Technical Memorandum: Review of MW Proposed DSS for Casey Fields South (Employment) and Devon Meadows PSPs

Date: 31/03/2025
Project Number: 2101096, 2102129, 2300328
Project Name: Casey Fields South (Employment) & Devon Meadows PSP drainage strategy consultation
Authors: [REDACTED]
Reviewer: [REDACTED]
Version: 1

DM3 & 4

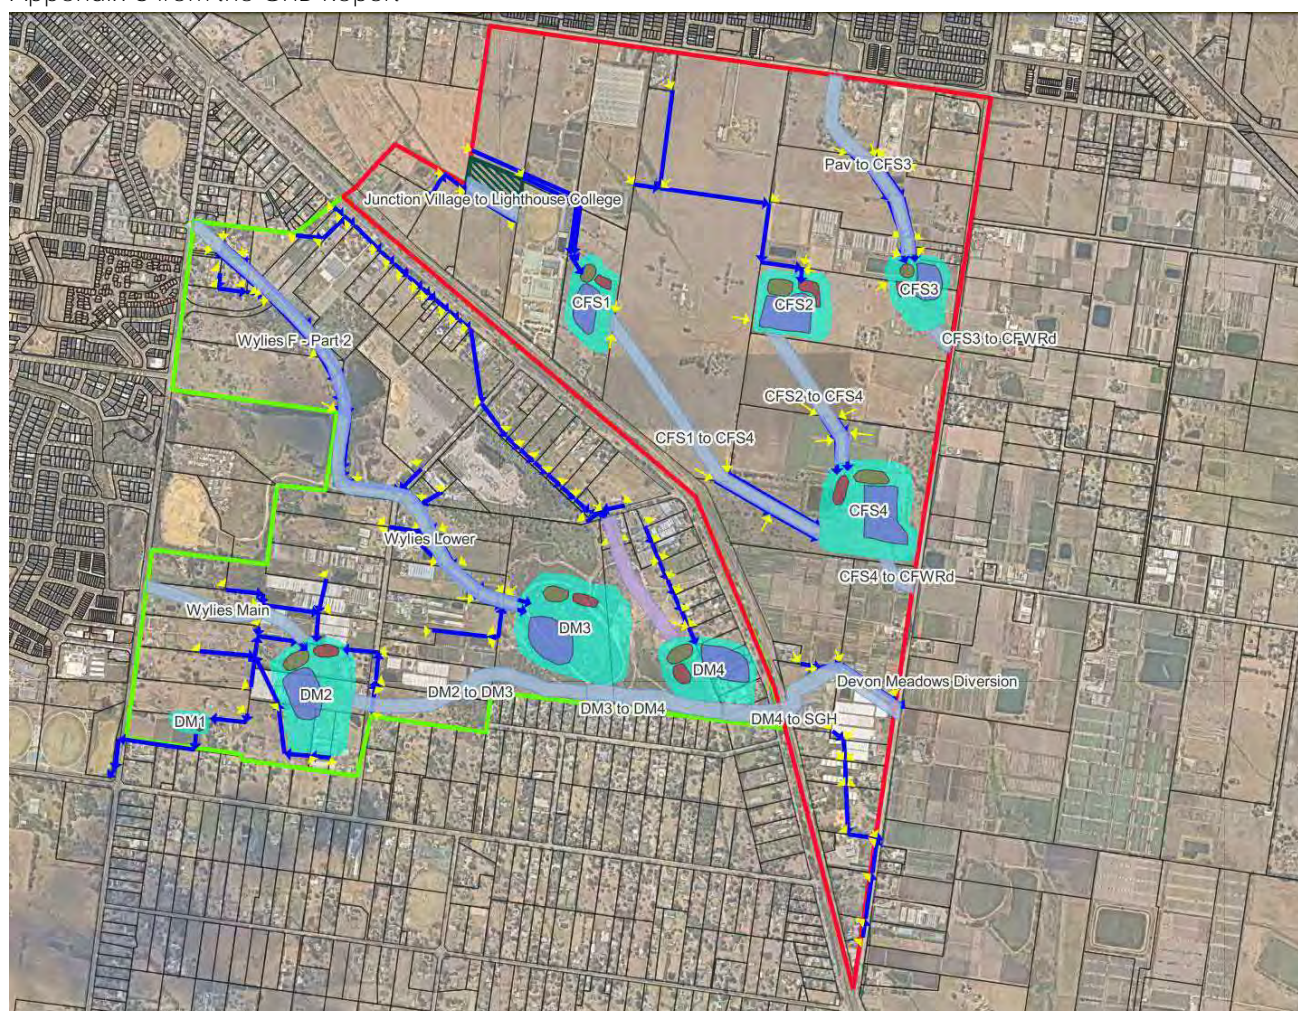
- The water balance modelling indicates that the development of Devon Meadows will increase the volumetric runoff by an average of 550 ML per year. As shown in calculations below, this volume would be enough to fill a large farm dam and could be conveyed under gravity by a single 225mm pipe.

- @DM2 using the means – 1335 ML/y – 1185 ML/yr = 150 ML/yr
- @DM3&4 using the means – 2048 ML/y – 1633 ML/yr = 415 ML/yr
- Therefore, total available excess volume from Devon Meadows is approx =565 ML/y
- This is enough to fill a single 2.8ha dam approx 2m deep every year, which is comparable to some of the larger farm dams downstream
- If this volume was conveyed under gravity a flow rate of approx 18 L/s would be required, which could be conveyed in a single 225mm pipe at 0.5% grade (capacity approx 32 L/s)

Long Section of the Diversion Channel Between DM2 and DM3

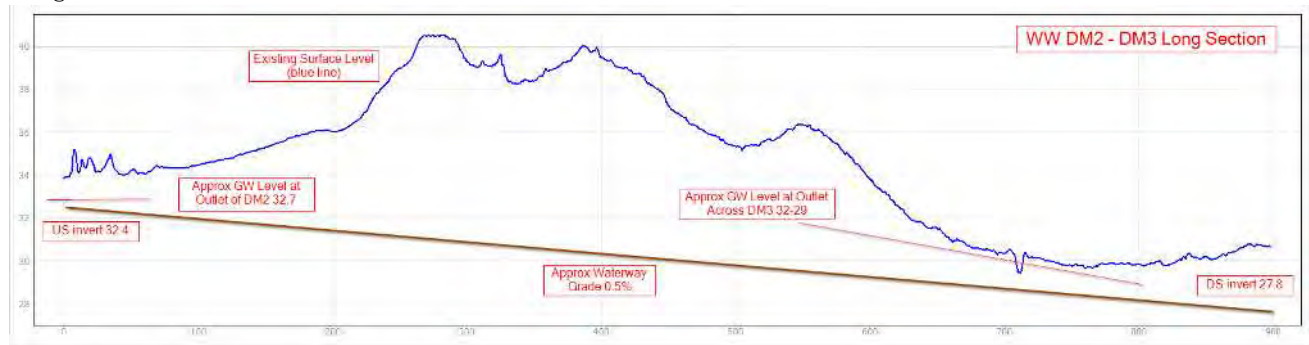
- BW have used the 1m LiDAR and levels summarised in GHDs report to try and understand how the channel works with the terrain and groundwater levels.
 - Preliminary analysis indicates that the diversion channel requires significant cut to achieve the required levels, particularly between basins DM2 and DM3.

- At its deepest, up to 10m of cut will be required which, with the proposed 1:5 batters, could require a reserve width of up to 100m at its widest rather than the 45m shown on GHDs concept plan. This would require a significant volume of earthworks to achieve with the associated significant cost.

- When compared with GHD's groundwater observations, it appears that significant sections of the channel are proposed to be below the groundwater level which raises several key issues:

- In summary, the proposed channel appears to be a drastic and expensive measure directed at solving a problem that was not properly assessed/quantified. It does not appear to even resolve

the perceived issue, instead just relocating it to a different location. We recommend abandoning the diversion channel proposal and focusing on a different solution to protect homes in Devon Meadows.

Northern Crossing (CFS3 to CFWRd)

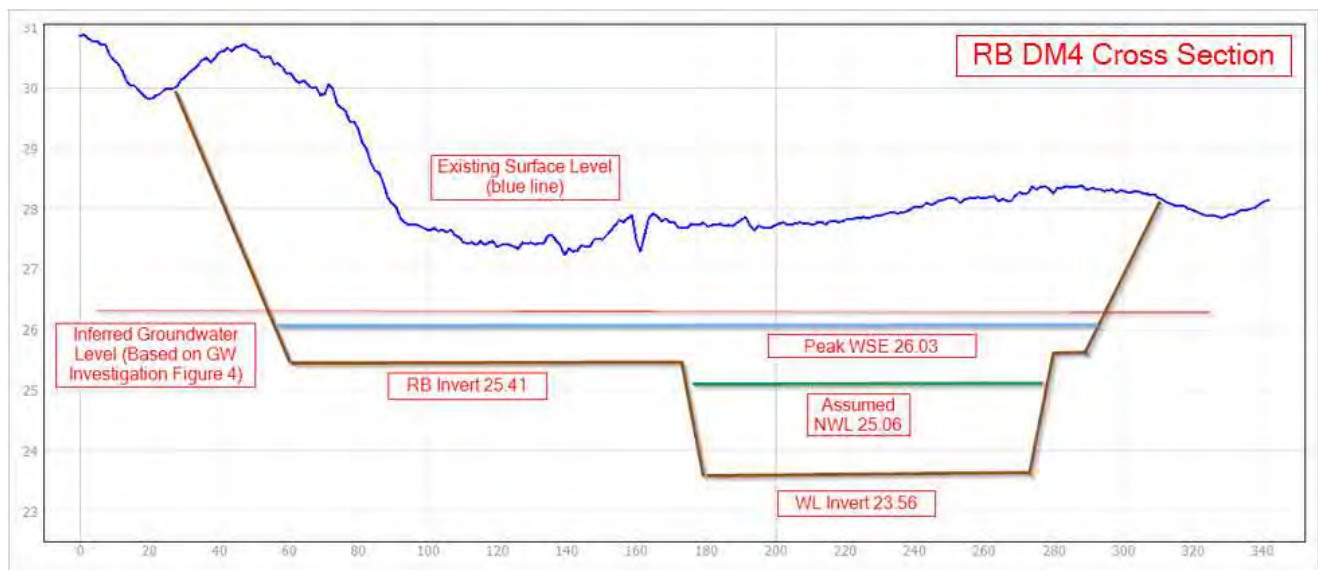
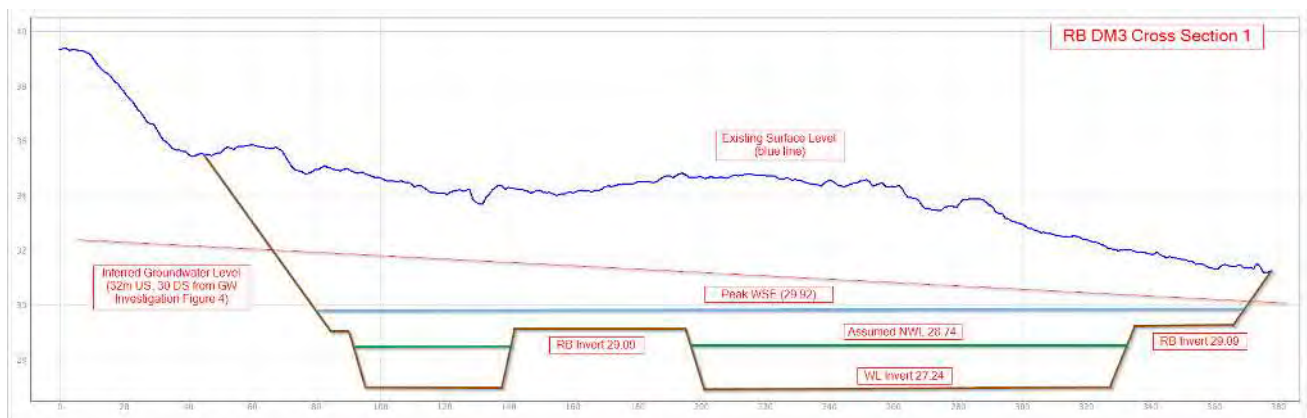
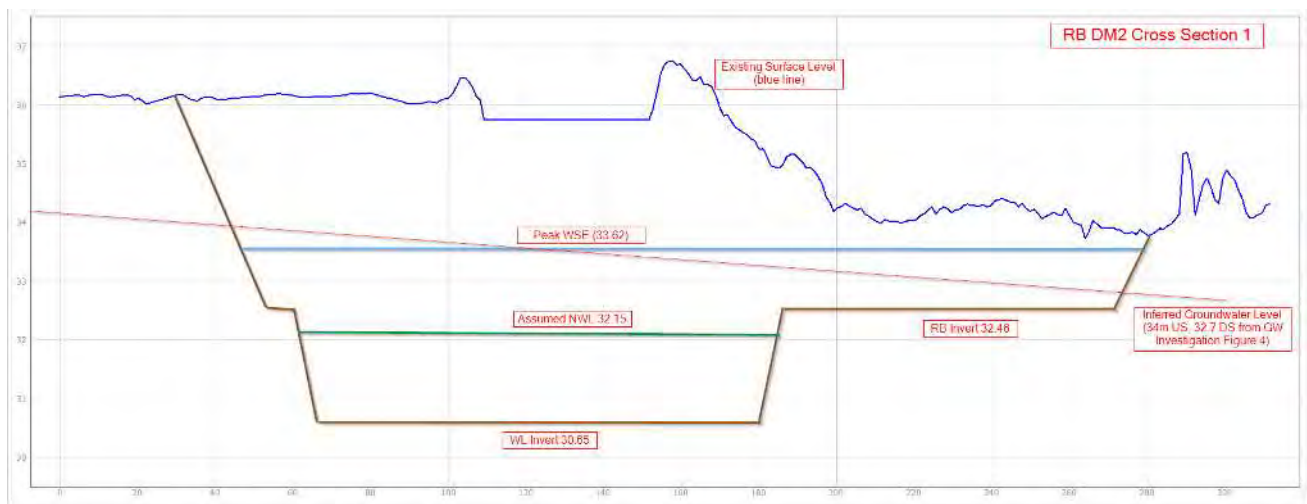
- Connection Points and Impact to Landowners in Clyde South
 - At this time, the proposed strategy relies on 3 connection points (shown in images below)

- These points are characterised by:
 - Roads being only marginally above the surrounding floodplain
 - An absence of any major drainage features, which are at best a small drainage channel and culvert and at worst no drainage feature at all

- The following is unclear:
 - How the proposed connections will work:
 - What will they connect to where no channel exists, will there be a requirement to extend the channel until an appropriate discharge point is reached?

- Is it proposed to lower the channel or raise Clyde Five Ways Rd to construct sufficient culvert crossings?
 - How will these works impact the existing landowners

- Under the current agricultural land use downstream, how will downstream properties manage additional flows from proposed upstream works, especially from increased volumetric discharge from Casey Fields (similar to the Devon Meadows issue) and both volumetric and flood flows from Devon Meadows relocated via the diversion drain.

- We would recommend that further analysis be undertaken to address the above questions prior to adoption of the proposed strategy.
